SURRY POWER STATION UNIT NO. 1

Amendment No. 7
License No. DPR-32

ATTACHMENT TO LICENSE AMENDMENT NO. 7
CHANGE NO. 22 TO THE TECHNICAL SPECIFICATIONS
FACILITY OPERATING LICENSE NO. DPR-32
DOCKET NO. 50-280

ATTACHMENT TO LICENSE AMENDMENT NO. 7
CHANGE NO. 22 TO THE TECHNICAL SPECIFICATIONS
FACILITY OPERATING LICENSE NO. DPR-37
DOCKET NO. 50-281

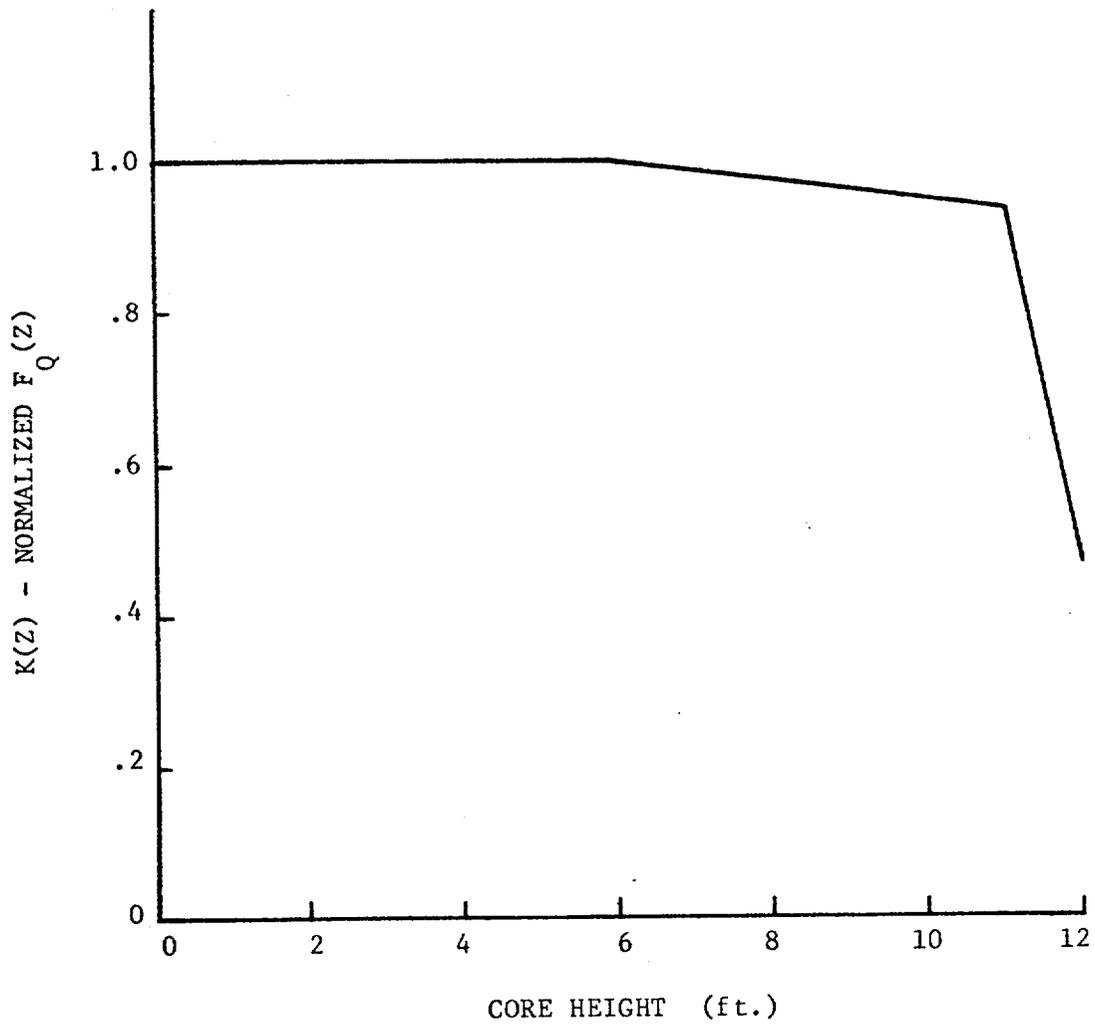
The technical specifications on power distribution control given in 3.12.B.4 assure that the F_Q upper bound envelope of 2.10 times Figure 3.12-8 is not exceeded and xenon distributions are not developed which at a later time, would cause greater local power peaking even though the flux difference is then within the limits specified by the procedure.

In some instances of rapid unit power reduction automatic rod motion will cause the flux difference to deviate from the target band when the reduced power level is reached. This does not necessarily affect the xenon distribution sufficiently to change the envelope of peaking factors which can be reached on a subsequent return to full power within the target band, however, to simplify the specification, a limitation of one hour in any period of 24 hours is placed on operation outside the band. This ensures that the resulting xenon distributions are not significantly different from those resulting from operation within the target band. The instantaneous consequences of being outside the band, provided rod insertion limits are observed, is not worse than a 10 percent increment in peaking factor for the allowable flux difference at 90% power, in the range +14.5 to -21 percent (+11.5 percent to -18 percent indicated) where for every 4 percent below rated power, the permissible positive flux difference boundary is extended

by 1 percent, and for every 5 percent below rated power, the permissible negative flux difference boundary is extended by 2 percent.

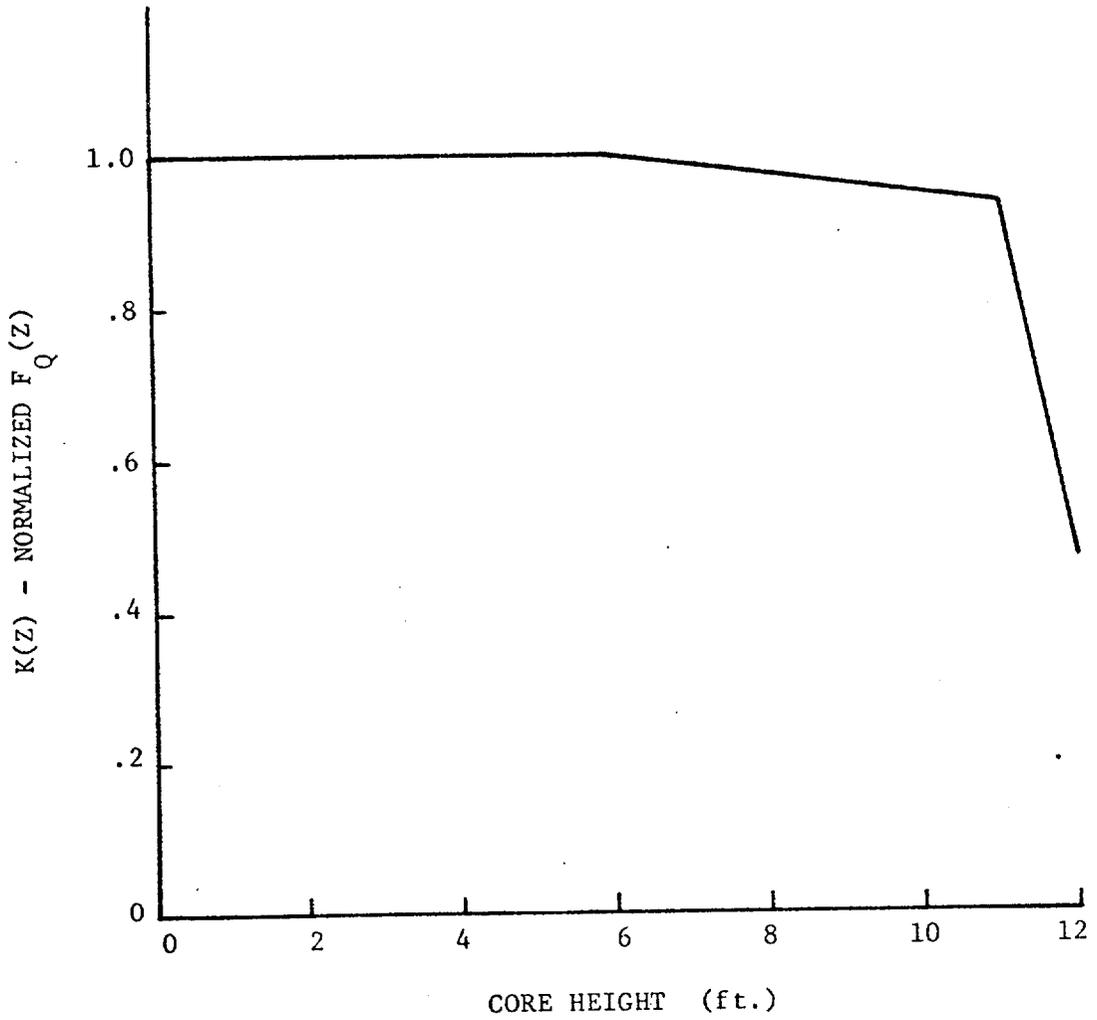
The technical specifications on power distribution control given in 3.12.B.4 assure that the F_Q upper bound envelope of 2.10 times Figure 3.12-8 is not exceeded and xenon distributions are not developed which at a later time, would cause greater local power peaking even though the flux difference is then within the limits specified by the procedure.

In some instances of rapid unit power reduction automatic rod motion will cause the flux difference to deviate from the target band when the reduced power level is reached. This does not necessarily affect the xenon distribution sufficiently to change the envelope of peaking factors which can be reached on a subsequent return to full power within the target band, however, to simplify the specification, a limitation of one hour in any period of 24 hours is placed on operation outside the band. This ensures that the resulting xenon distributions are not significantly different from those resulting from operation within the target band. The instantaneous consequences of being outside the band, provided rod insertion limits are observed, is not worse than a 10 percent increment in peaking factor for the allowable flux difference at 90% power, in the range +14.5 to -21 percent (+11.5 percent to -18 percent indicated) where for every 4 percent below rated power, the permissible positive flux difference boundary is extended

by 1 percent, and for every 5 percent below rated power, the permissible negative flux difference boundary is extended by 2 percent.
